# Access Compliance Report Public Rights-of-Way (Curb Ramps)

Main Street: MAIN\_ST Cross Street: WELBE\_CIR Location: SE

ADA ID: RPRK211101133646 Ramp Type: Type 4 - Parallel Initial Pass/Fail: Fail Overall Compliance: No Severity Score: 32

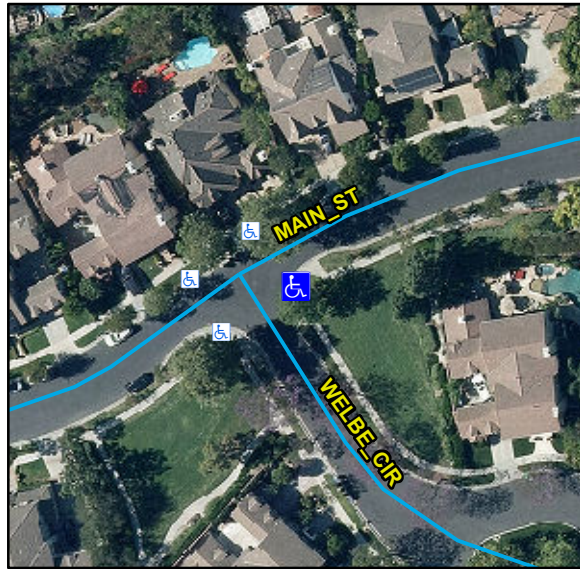
R204.3, R304.5.3, R304.3.2, STD 1115

| Compliance | Description                   | Data       | Compliance | Description                   | Data |
|------------|-------------------------------|------------|------------|-------------------------------|------|
| Yes        | Ramp Run Slope LT (%)         | 1.9        | No         | Ramp Run Slope RT (%)         | 12.1 |
| No         | Ramp Cross Slope LT (%)       | 3.2        | Yes        | Ramp Cross Slope RT (%)       | 0.4  |

Remove & Replace Curb Ramp With Two New Directional Ramps or Equivalent.
